CITY OF PROVIDENCE, RHODE ISLAND

RFP Title: Site Improvements at Billy Taylor Park

Addendum #: 2

The purpose of this addendum is to provide updates from pre-bid meeting, revisions to plans, bid package specifications and prevailing wage.

DRAWING INFO
DATE ISSUED: 03/23/26
PROJECT NO: BILL 22.04
DRAWN BY: NM, SG, NC
CHECKED BY: MG
SHEET TITLE
Splashpad Plan

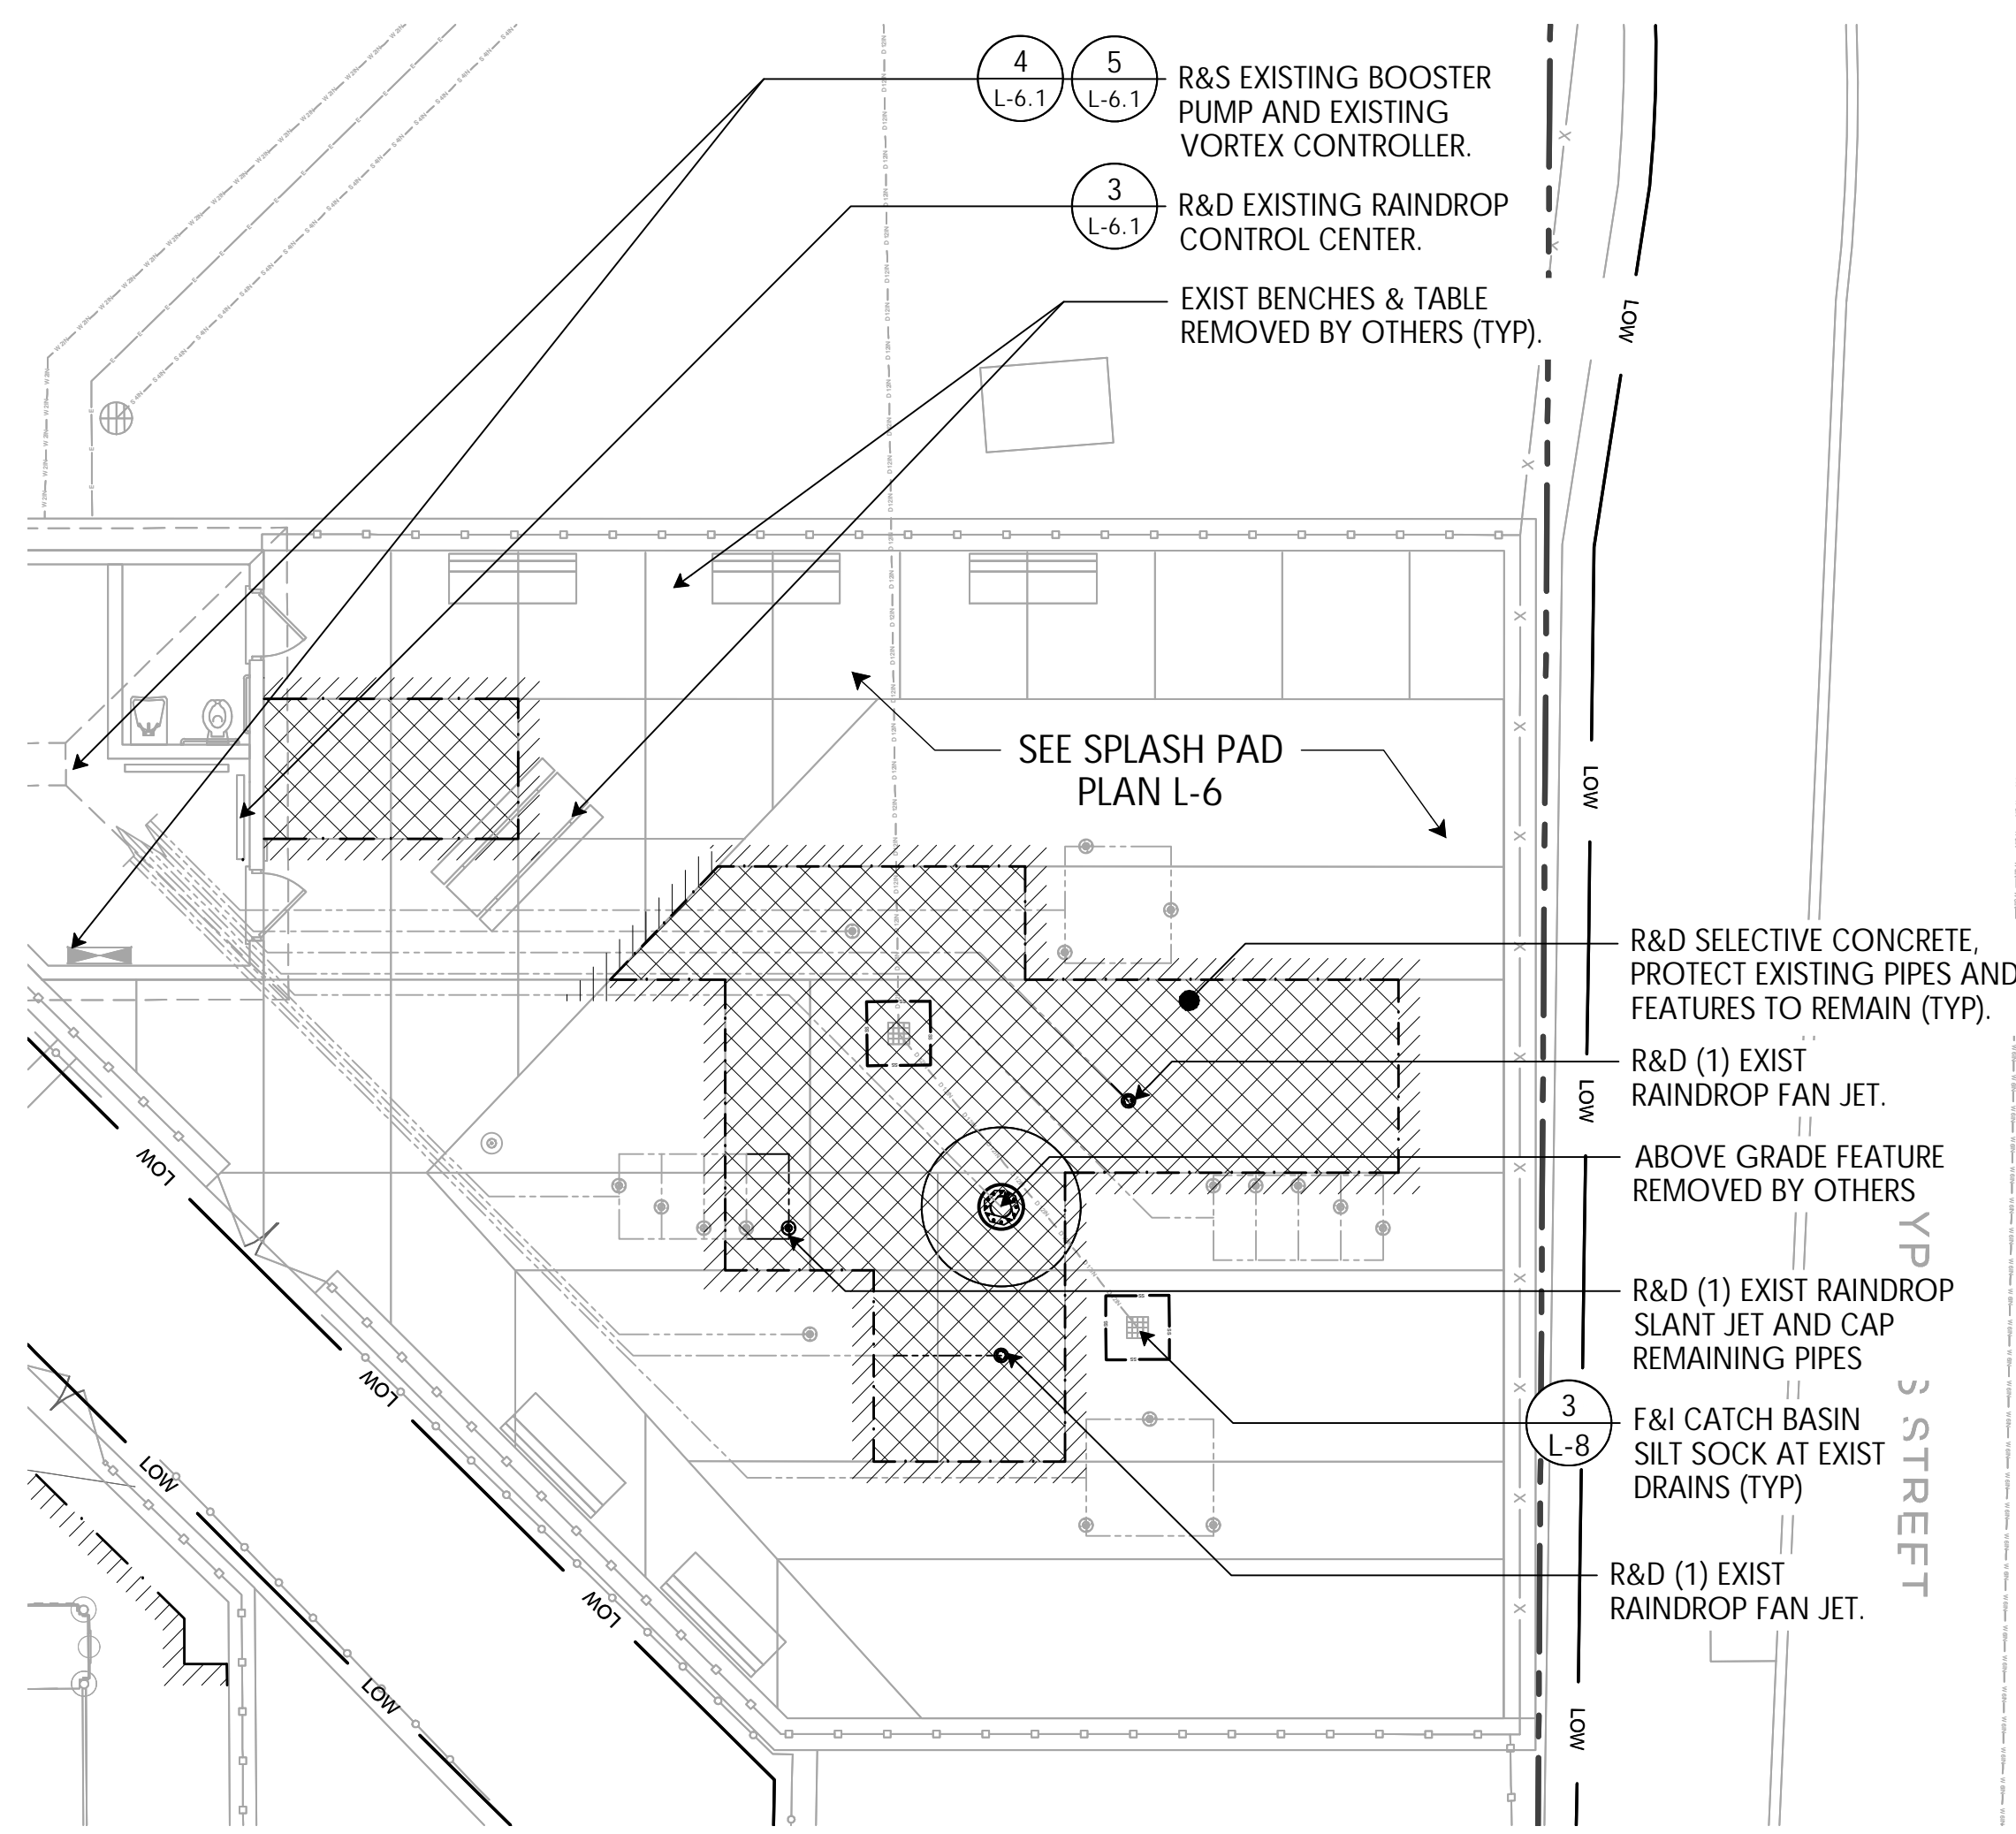
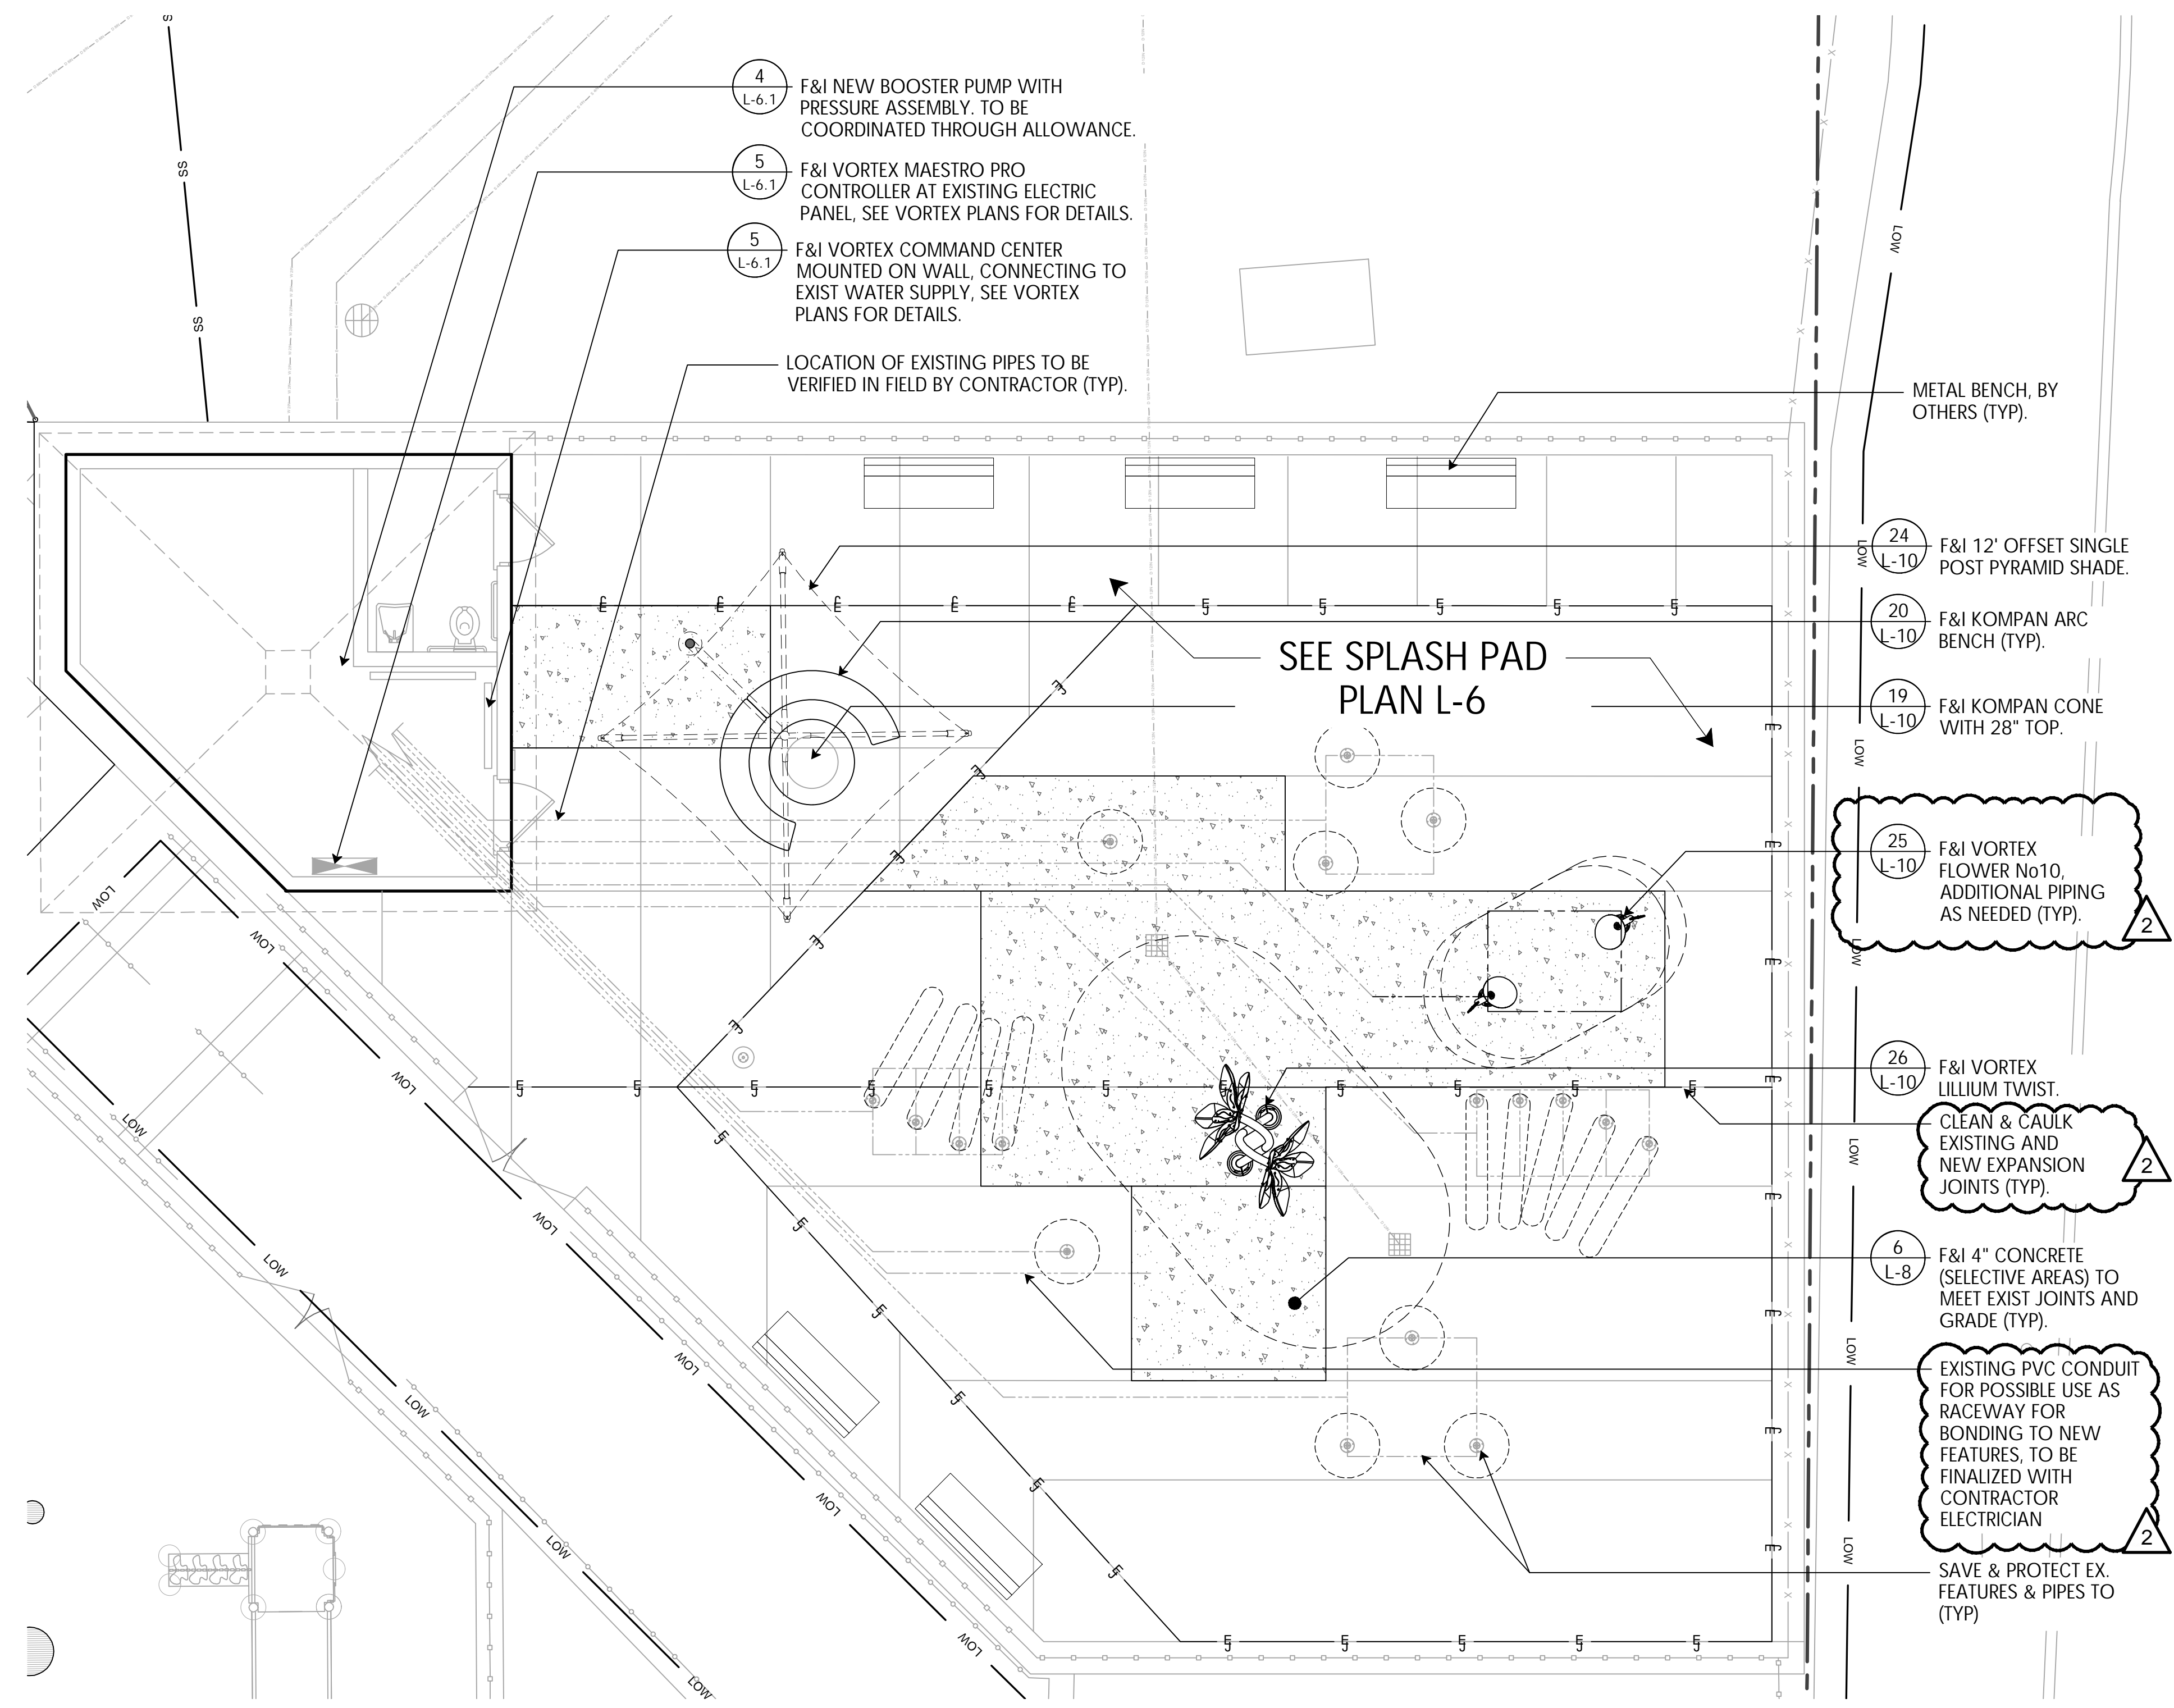
11. Q: Is manifold in the splash pad building being replaced?
A: Yes

13. Q: Will bonding plan be complete before bid deadline?
A: See addendum plans.

NOTES:
1. ALIGN PROPOSED JOINTS WITH EXISTING, SEE DETAILS & SPECS.
2. BONDING TO BE COORDINATED WITH ELECTRICIAN UNDER CONTRACT, PER CODE.
